World Forum for Harmonization of Vehicle Regulations

Proposal for the 02 series of amendments to Regulation No. 94 (Frontal collision protection)

Submitted by the Working Party on Passive Safety *

Figure 1

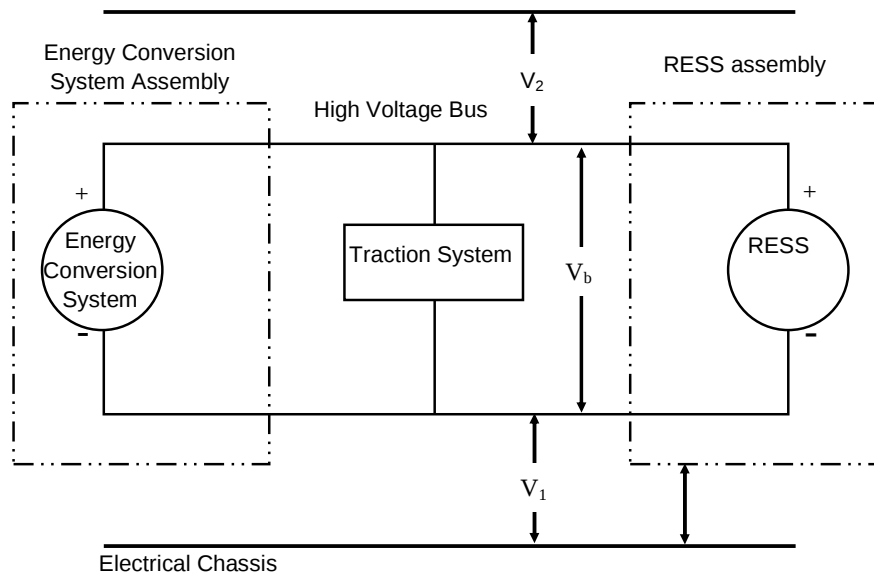
After the impact test, determine the high voltage bus voltages (V_b , V_1 , V_2) (see figure 1).

The voltage measurement shall be made not earlier than 5 seconds, but, not later than 60 seconds after the impact.

Measure and record the voltage (V_b) between the negative and the positive side of the high voltage bus (see figure 1);

Measure and record the voltage (V_1) between the negative side of the high voltage bus and the electrical chassis (see figure 1);

Measure and record the voltage (V_2) between the positive side of the high voltage bus and the electrical chassis (see figure 1);

Figure 2

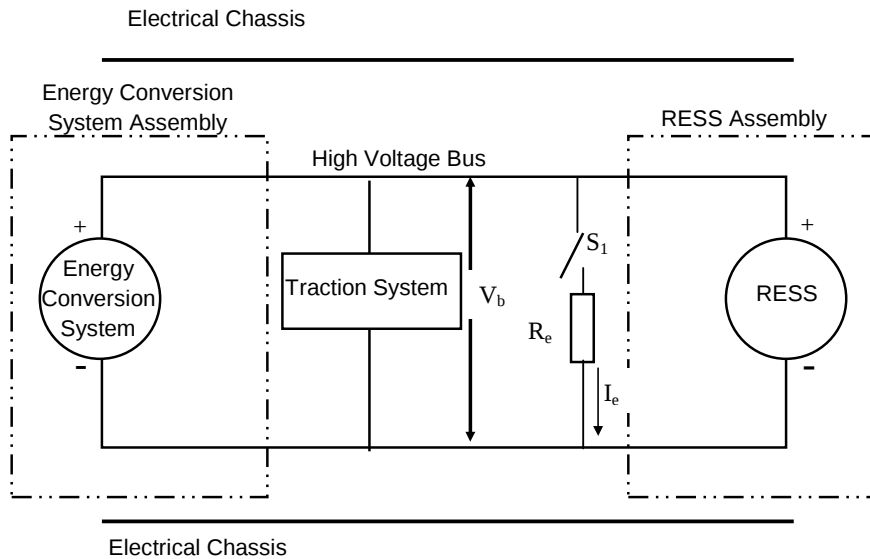
Prior to the impact a switch S_1 and a known discharge resistor R_e is connected in parallel to the relevant capacitance (ref. figure 2).

Not earlier than 5 seconds and not later than 60 seconds after the impact the switch S_1 shall be closed while the voltage V_b and the current I_e are measured and recorded. The product of the voltage V_b and the current I_e shall be integrated over the period of time, starting from the moment when the switch S_1 is closed (t_c) until the voltage V_b falls below the high voltage threshold of 60 V DC (t_h). The resulting integration equals the total energy (TE) in joules.

Figure 3
Measurement of V_1'

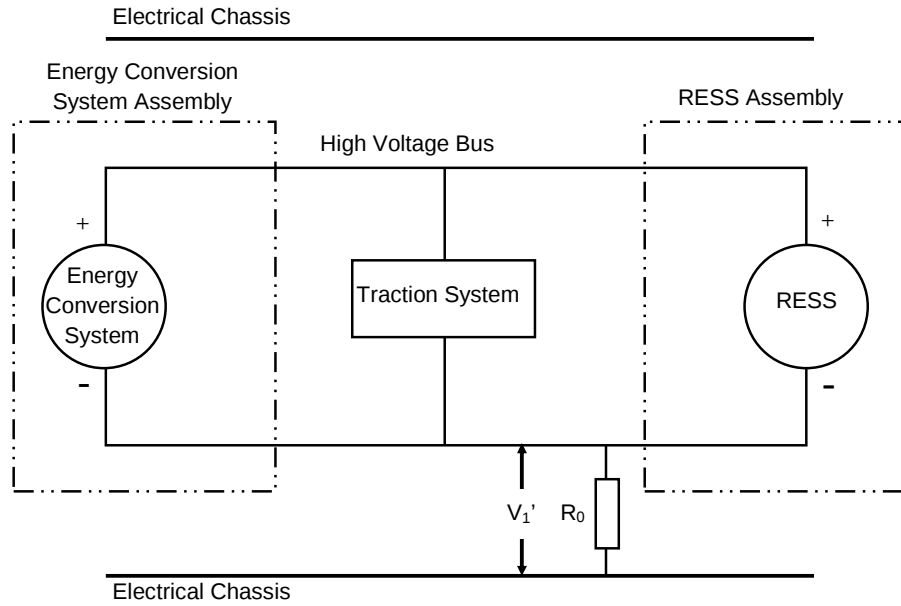
If V_1 is greater than or equal to V_2 , insert a standard known resistance (R_o) between the negative side of the high voltage bus and the electrical chassis. With R_o installed, measure the voltage (V_1') between the negative side of the high voltage bus and the vehicle electrical chassis (see figure 3). Calculate the isolation resistance (R_i) according to the formula shown below.

$$R_i = R_o * (V_b / V_1' - V_b / V_1) \quad \text{or} \quad R_i = R_o * V_b * (1/V_1' - 1/V_1)$$

Figure 4
Measurement of V_2'

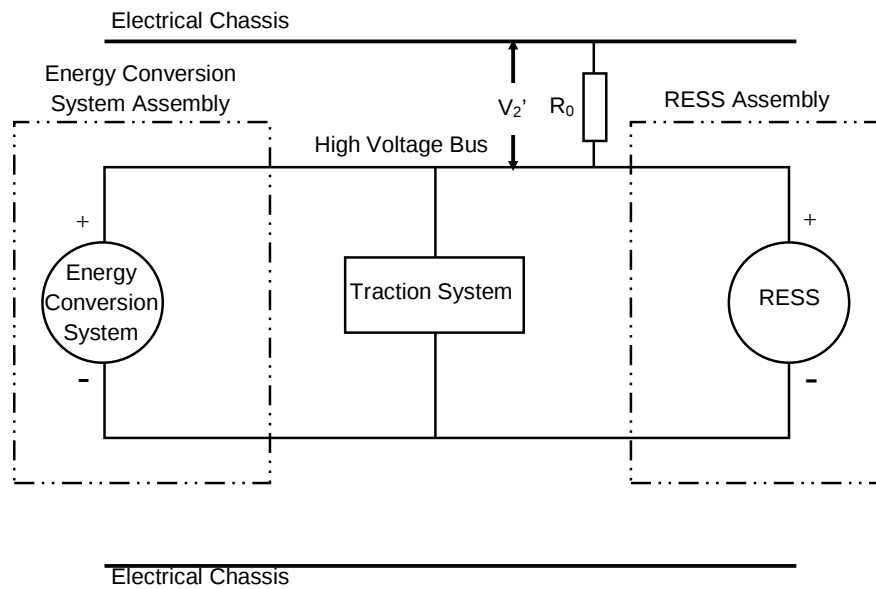
If V_2 is greater than V_1 , insert a standard known resistance (R_o) between the positive side of the high voltage bus and the electrical chassis. With R_o installed, measure the voltage (V_2') between the positive side of the high voltage bus and the electrical chassis (see figure 4).

Calculate the isolation resistance (R_i) according to the formula shown below.

$$R_i = R_o * (V_b / V_2' - V_b / V_2) \quad \text{or} \quad R_i = R_o * V_b * (1/V_2' - 1/V_2)$$

Figure 1
Jointed test finger

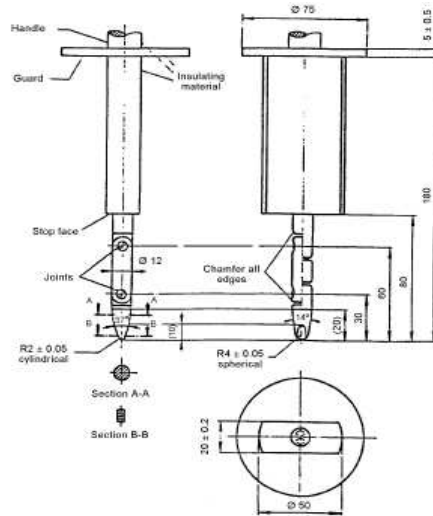
The Jointed Test Finger described in figure 1 of Appendix 1 shall be inserted into any gaps or openings of the physical protection with a test force of $10\text{ N} \pm 10\%$ per cent for electrical safety assessment. If partial or full penetration into the physical protection by the Jointed Test Finger occurs, the Jointed Test Finger shall be placed in every position as specified below.

Starting from the straight position, both joints of the test finger shall be rotated progressively through an angle of up to 90 degrees with respect to the axis of the adjoining section of the finger and shall be placed in every possible position.

The requirements of paragraph 5.2.8.1.3. shall be considered to be met if the Jointed Test Finger described in figure 1 of Appendix 1, is unable to contact high voltage live parts.
